# **802.3ck D2.1 Comment Resolution 120F, 163, 163A, 93A**

Matt Brown, Huawei, P802.3ck Editor-In-Chief  
Phil Sun, Credo  
Howard Heck, Intel

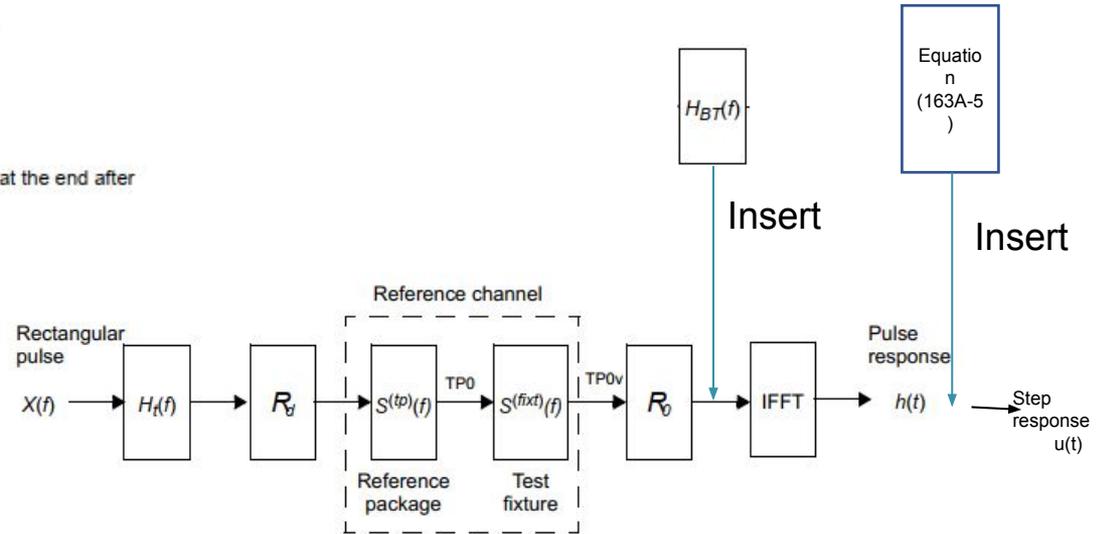
A measurement filter of BT filter is already included, because the step response is derived from the pulse response  $h(t)$  that uses the BT filter.

Figure 163A-3 is not correct, because the effect of BT filter is included.

Remove Editor's note in page 308.

Change Figure 163A-3 as follows:

Add  $H_{BT}(f)$  in the same way as Figure 163A-2.

Append a block of "Equation (163A-5)" followed by "Stepresponse  $u(t)$ " at the end after "Pulse response  $h(t)$ ".

PROPOSED ACCEPT.
